To: T10 Committee (SCSI)

From: George Penokie (IBM/Tivoli)

Subject: SAS: SP\_DWS Wording Changes

There has been confusion about how primitives and data dwords are handled in the SP\_DWS state machine. This proposal fixes that.

Figure 1 — SP\_DWS (phy layer dword synchronization) state machine

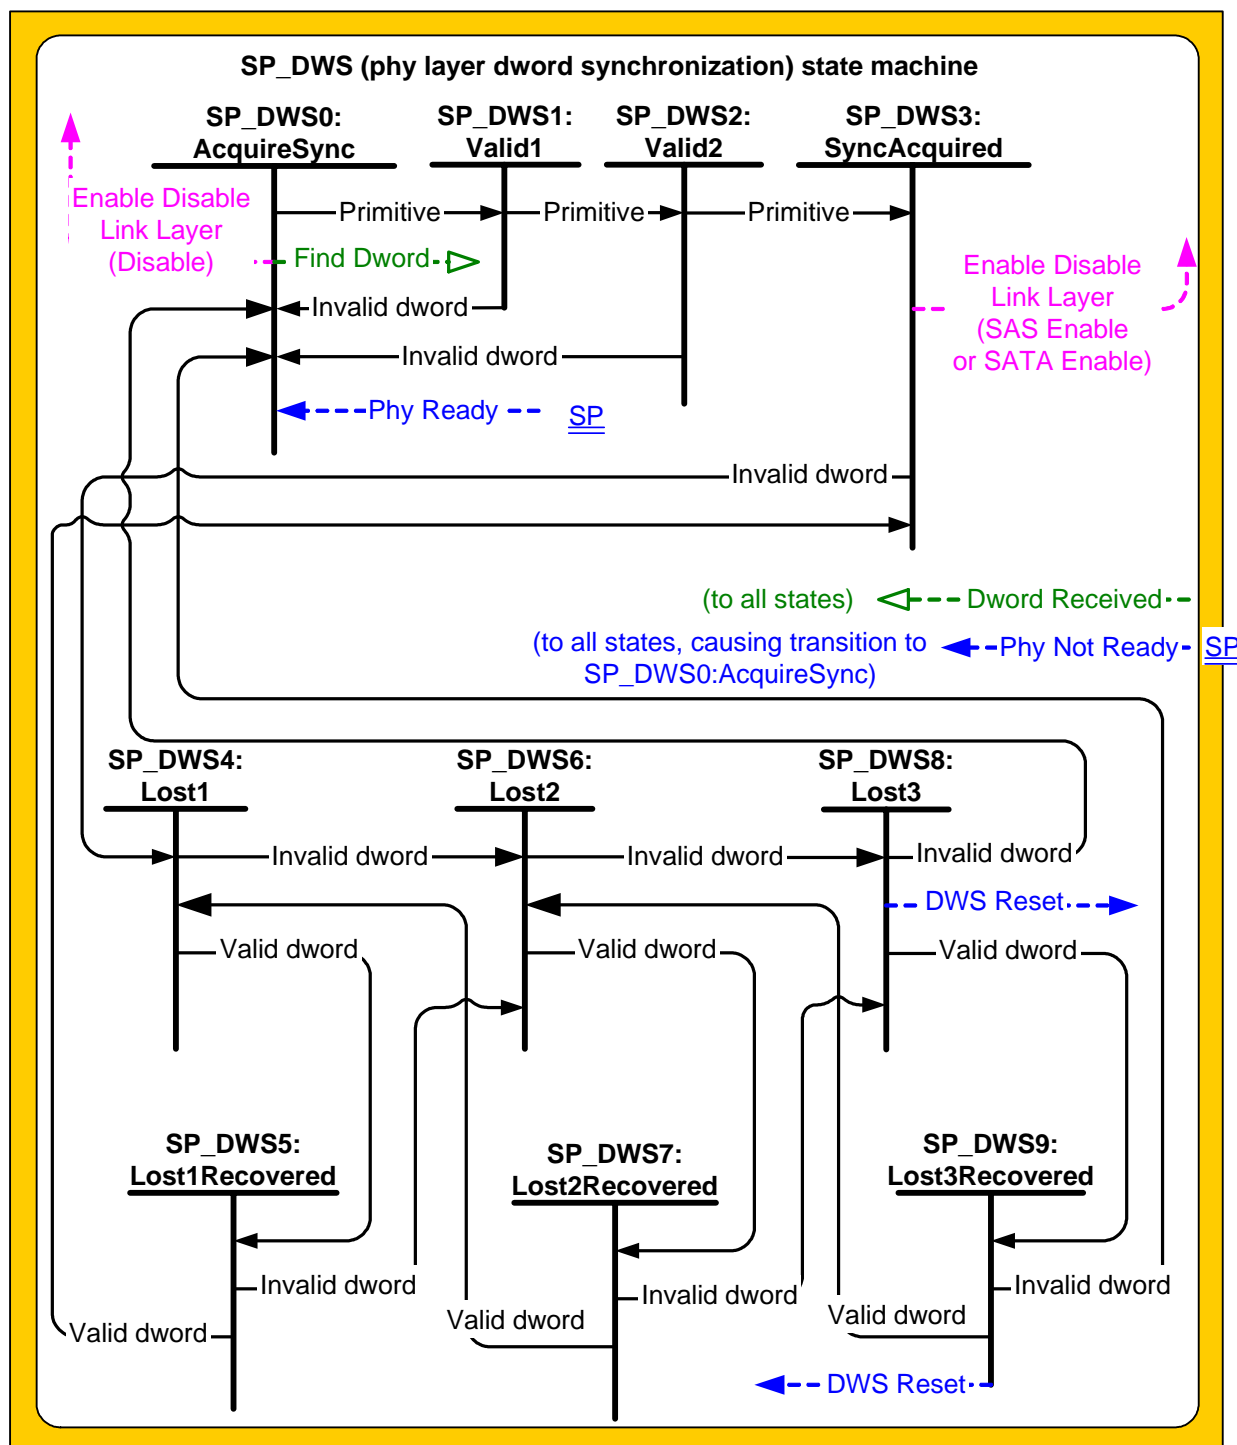
This state machine receives the following ~~parameters~~messages from the SP state machine (see 6.7):

This state machine sends the following ~~parameters~~messages to the SP state machine:

Figure 1 shows the SP\_DWS state machine.
